ADDRESS: 313 PINE ST
Proposal: Construct accessible entrance to Parish House
Review Requested: In concept
Owner: St. Peter's Protestant Episcopal Church
Applicant: Matthew McCarty, Voith & Mactavish Architects LLP
History: 1809; Reverend Robert Blackwell House; Robert Mills, architect
Individual Designation: 6/26/1956, 4/30/1957
District Designation: Society Hill Historic District, Significant, 3/10/1999
Staff Contact: Heather Hendrickson, heather.hendrickson@phila.gov

OVERVIEW: This application seeks an "in concept" review of a proposal to add an accessible entrance at St. Peter's Parish House at 313 Pine Street. The project proposes a gently sloping ramp and stairs to a doorway that would provide a dignified accessible entrance while respecting the historic character of the Parish House and its setting. The new accessible entrance would be located on the west or side facade along St. Peter's Way, a public walkway. The west facade of the building was historically a hidden party wall; it was exposed in 1964 when the adjacent house was demolished for the walkway. At that time, a brick veneer with windows and a bargeboard were added to the west wall. The applicant is seeking feedbac

Proposed Rendering
St. Peter's Parish House
313 Pine Street (Facing Northeast)

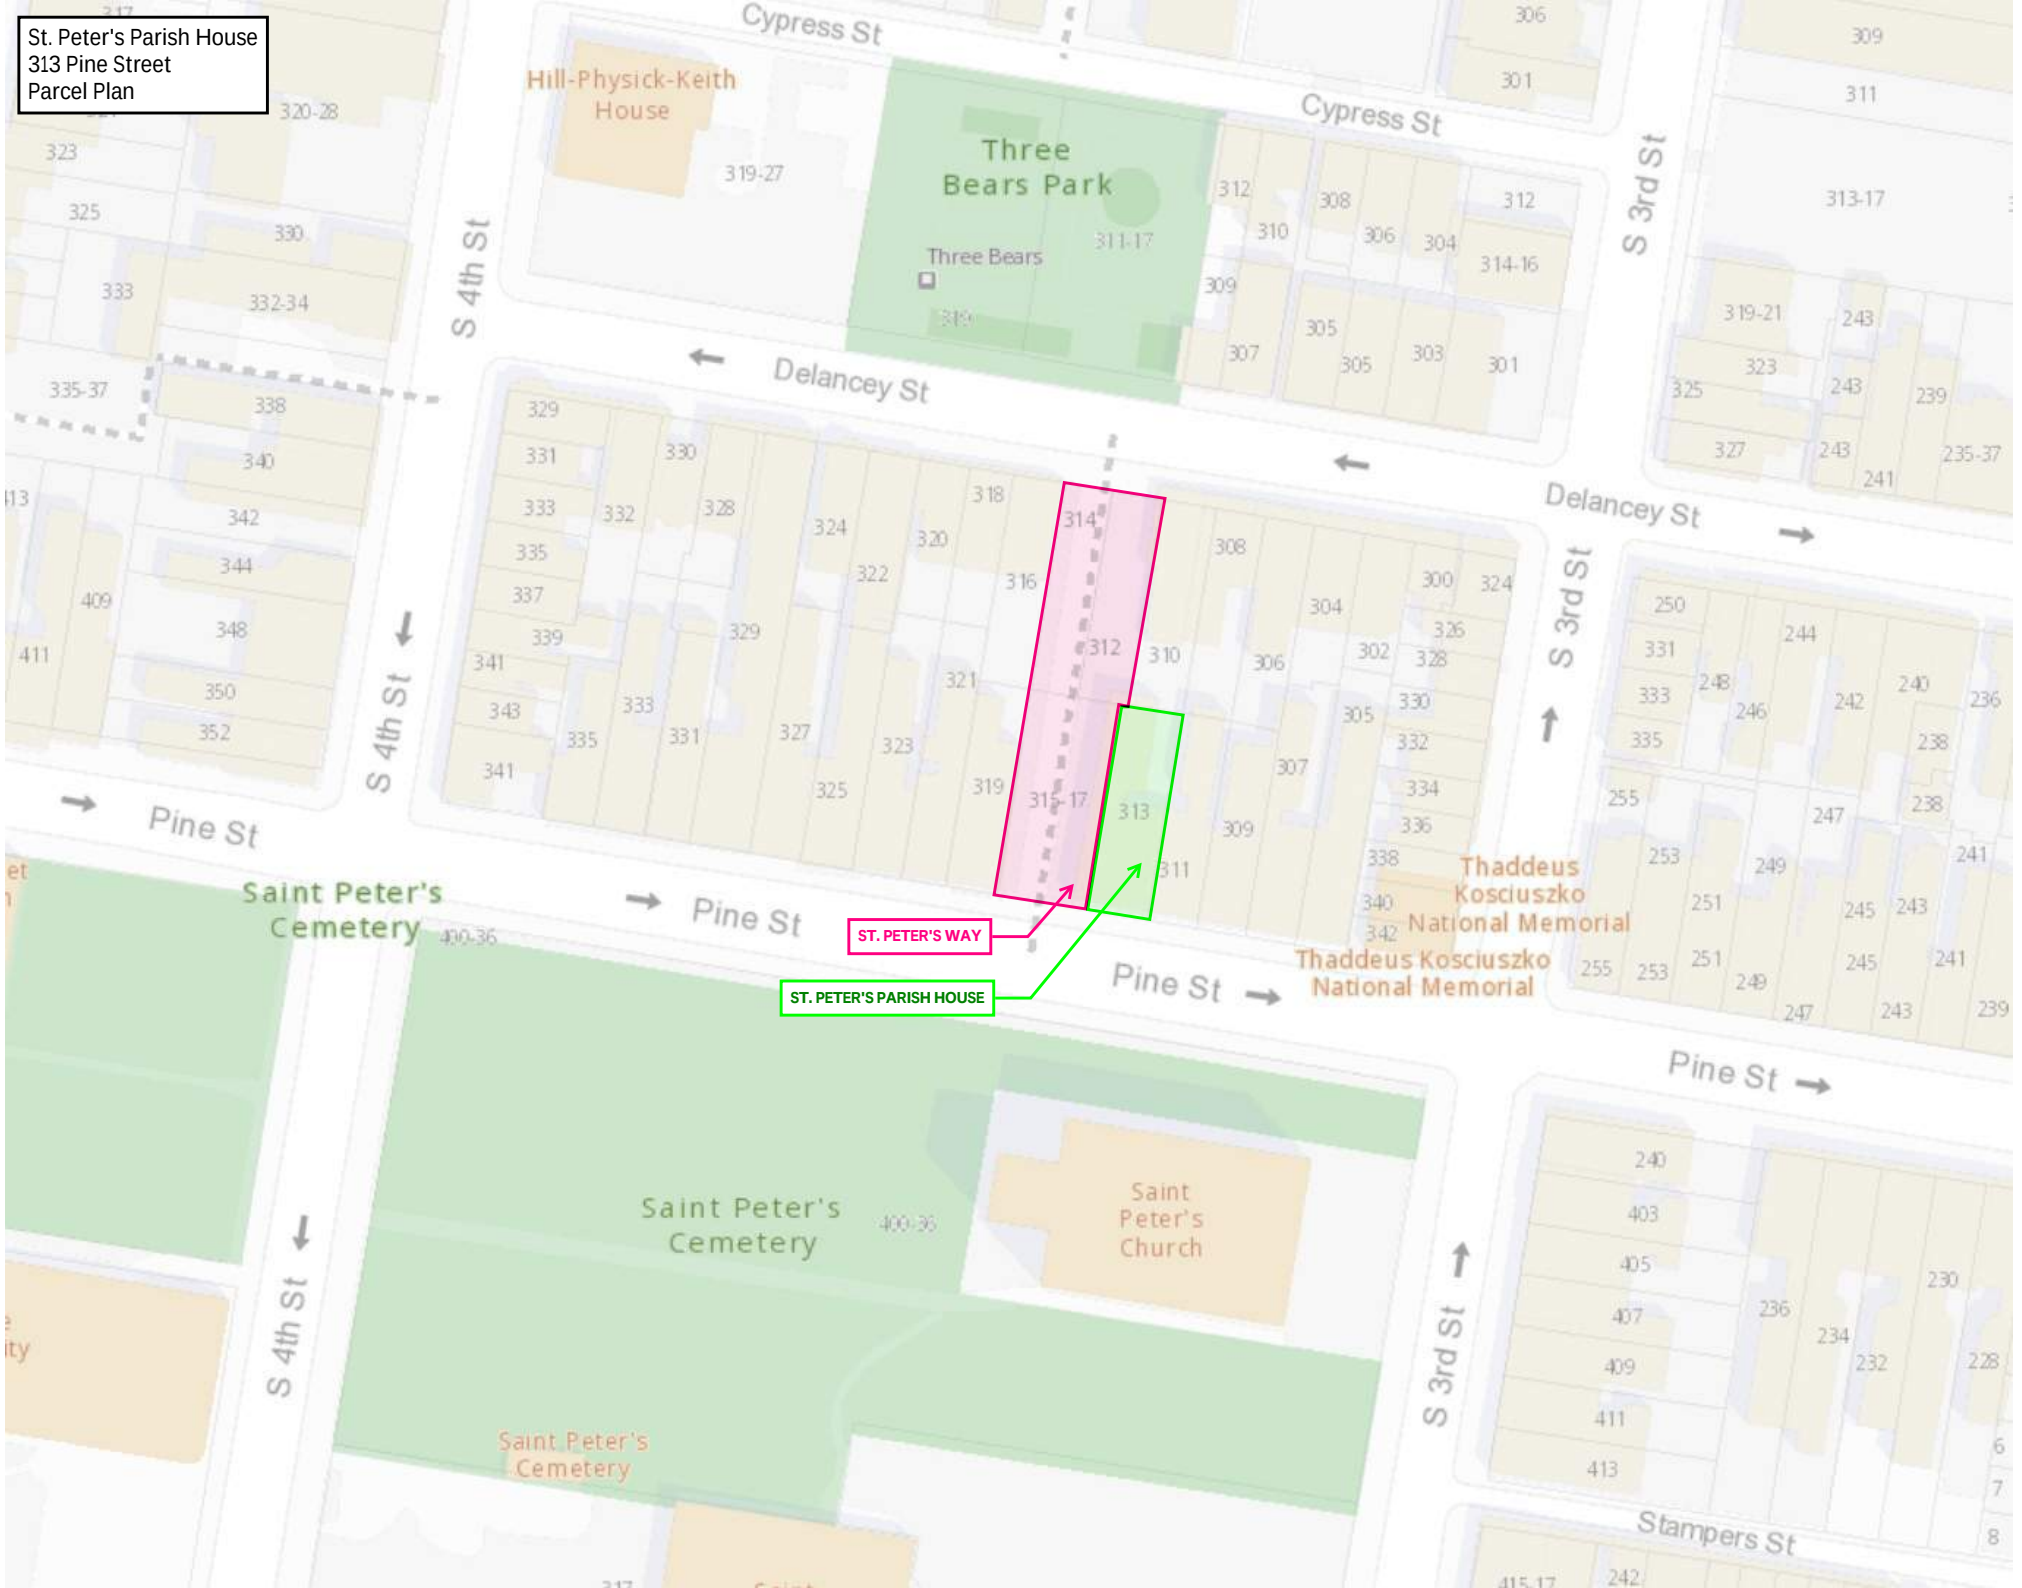
- The doorway should be detailed in such a way that it is not confused for an original feature.
- *Standard 9: New additions, exterior alterations, or related new construction will not destroy historic materials, features, and spatial relationships that characterize the property. The new work will be differentiated from the old and will be compatible with the historic materials, features, size, scale and proportion, and massing to protect the integrity of the property and its environment.*

- No historic materials, features, or spatial relationships will be altered or destroyed with the addition of the ramp and doorway. The proposed ramp and doorway are compatible with the historic resource's materials, features, size, scale, proportion, and massing. The doorway should be detailed in such a way to be differentiated from the historic features.

STAFF RECOMMENDATION: Approval in concept, provided the doorway is both compatible with and differentiated from the historic features, pursuant to Standards 3 and 9.
